## REVISED RESPONSE TO REQUEST FOR ADDITIONAL INFORMATION

### APR1400 Design Certification

Docket No. 52-046

**RAI No.:** 114-8041  
**SRP Section:** 03.04.01 – Internal Flood Protection for Onsite Equipment Failures  
**Application Section:** 3.4.1  
**Date of RAI Issue:** 07/27/2015

Figure 3 Flow Opening Schematic drawing on El. 100 ft

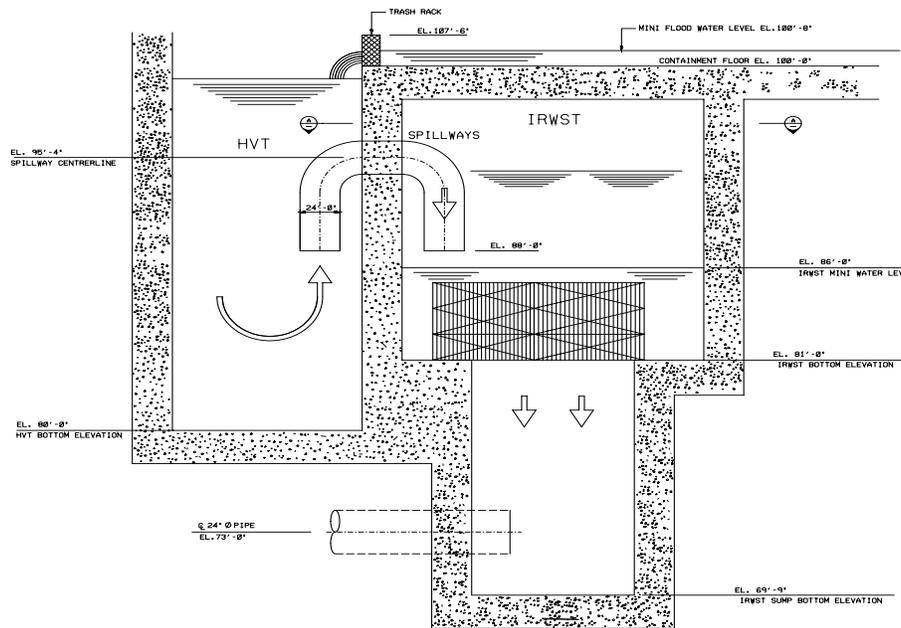
- b) Explain the basis for the determination of the worst case being LOCA with duration of 50 second. It should be noted that LOCA has higher peak flow but drops quickly lasting much longer than 50 second, while fire protection water could leak indefinitely without isolation resulting in larger volume of flood water. If isolation is used, provide the design basis and justifications.

- c) Explain how other in-containment water sources (such as main feedwater line, main steam line, auxiliary feedwater system, shutdown cooling system, component cooling system, safety injection tank (SIT), and other water carrying piping) compare against the worst case LOCA?

The flowrate through the opening is generally calculated by using the weir equations as depicted in Table 2 below. The shape of floor openings at EL.100 ft is similar to the sharp-crested rectangular and broad-crested rectangular weirs from Figures 1 through 3; thus, the associated equations are appropriate to use to calculate the flow rate in APR1400 DC.

The swirling effect is considered negligible since the floor opening width is sufficiently large and the flood source due to a FW line break would flow to EL.136 ft, down to EL.114 ft and finally to EL.100 ft of the containment building through gratings or stairwells. Thus, the flow rate will be decreasing such that the swirling effect is not significant.
